SUBJECT: Board Approval of Change Order 9-04, EXCEL Consolidation and Capital Improvements Project Phase 4–Ogdensburg Free Academy - Project Number: 2007-122E

No. 9-04

PROJECT: EXCEL Capital Improvement Project Phase 4 - OFA OWNER: Ogdensburg City School District 1100 State Street Ogdensburg, New York 13669 CONTRACTOR: S&L Electric (Name, Address) 5313 NYS Rt. 56 Colton, NY 13625 CONTRACT FOR: No. 9- Electrical CONTRACT DATE: January 6, 2014	DATE OF ISSUANCE: October 22, 2015 ENGINEER: Bernier Carr & Associates 327 Mullin Street Watertown, New York 13601 ENGINEER'S PROJECT NO.: 2007-122E SED PROJ. MGR.: Mary Sansaricq SED CONTROL NO.: 51-23-00-01-0-007-017 OFA
---	---

REQUEST FOR PROPOSAL

ELECTRICAL SINGLE LINE DIAGRAM A
 NOT TO SCALE

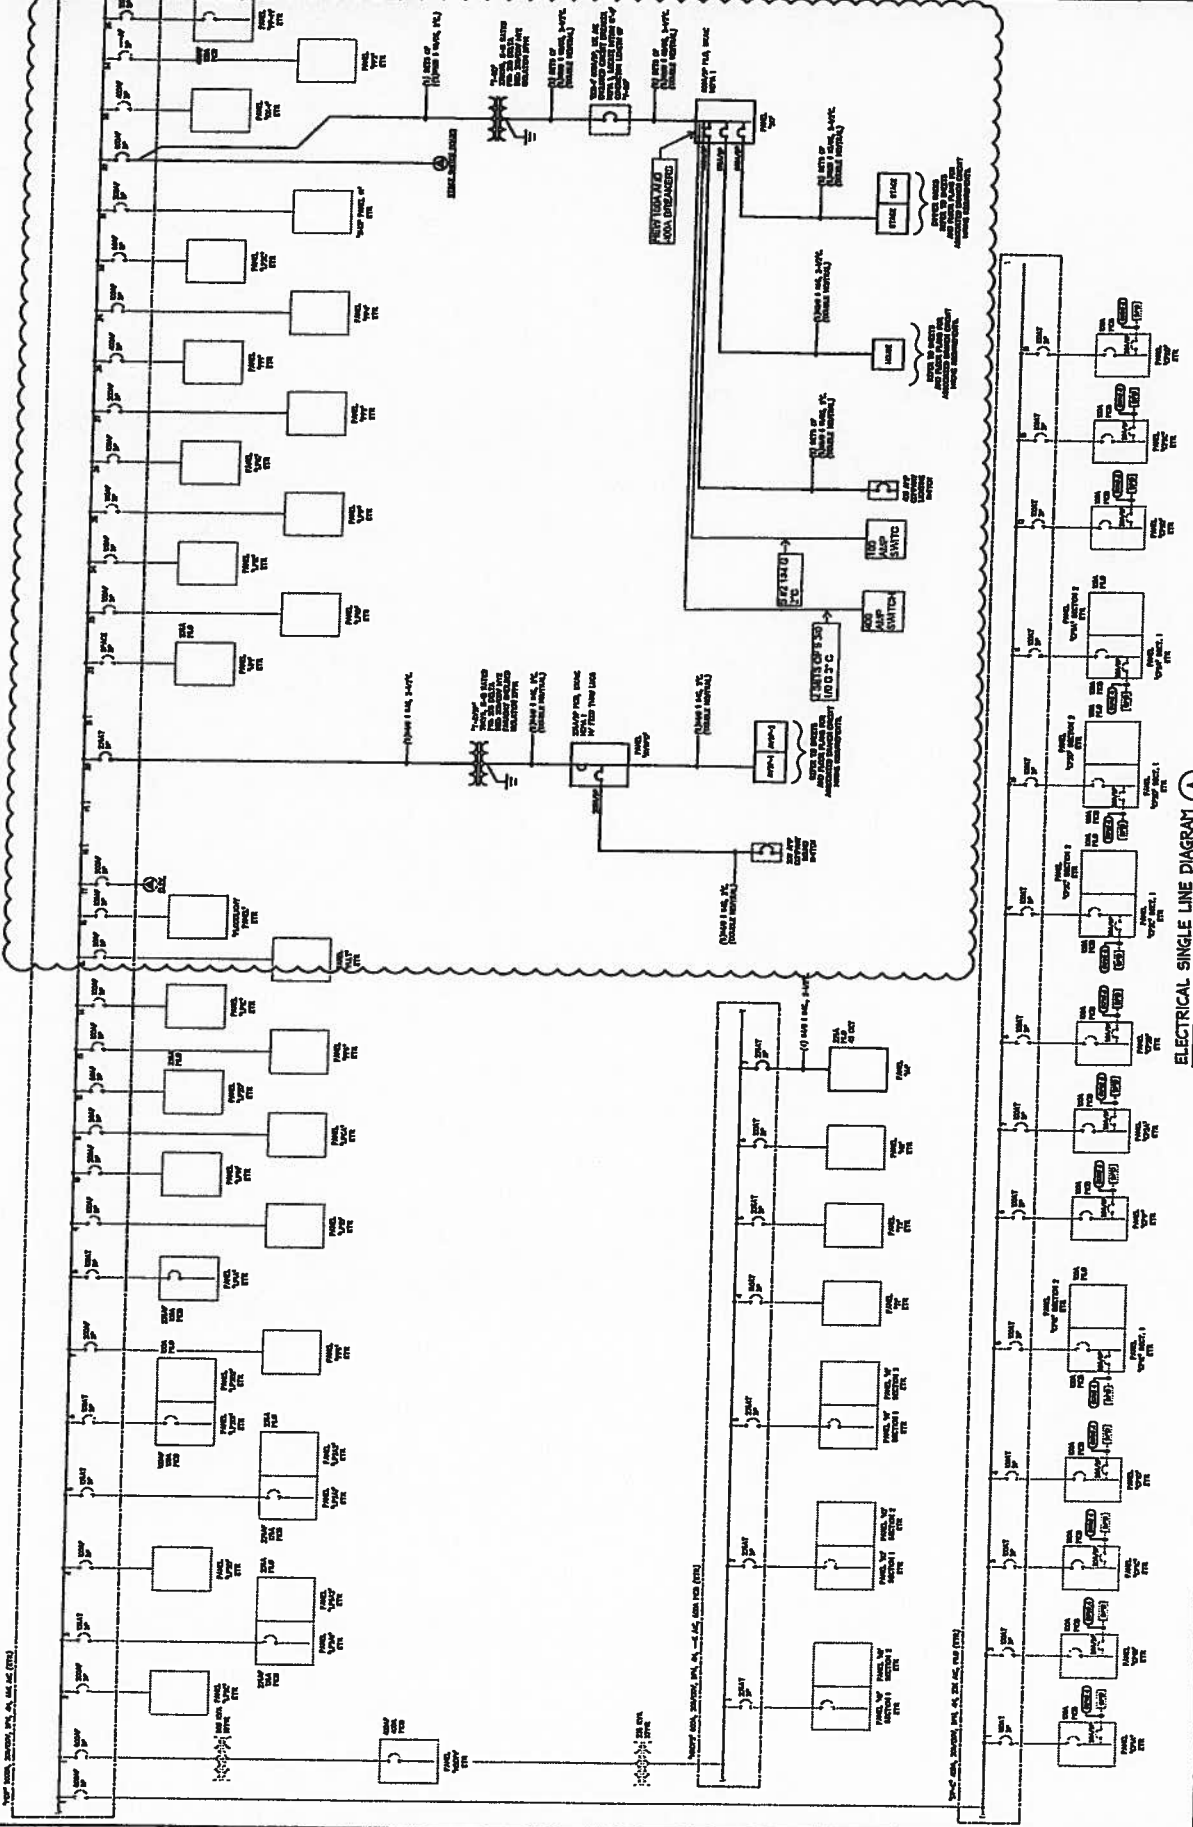
Add to provide 400 amp and 100 amp disconnects at panel SD to accommodate stage production power requirements. \$ 27,639.81

A	Owner requested power.
B	As part of the Capital Project, the auditorium was scheduled for reconstruction as per contract drawing A1-201.
C	During construction, Owner requested additional 400 amp and 100 amp disconnects on stage to accommodate equipment needs and versatility of various productions and technical shows.
D	Add to provide 400 amp and 100 amp disconnects at panel SD to accommodate stage production power requirements.
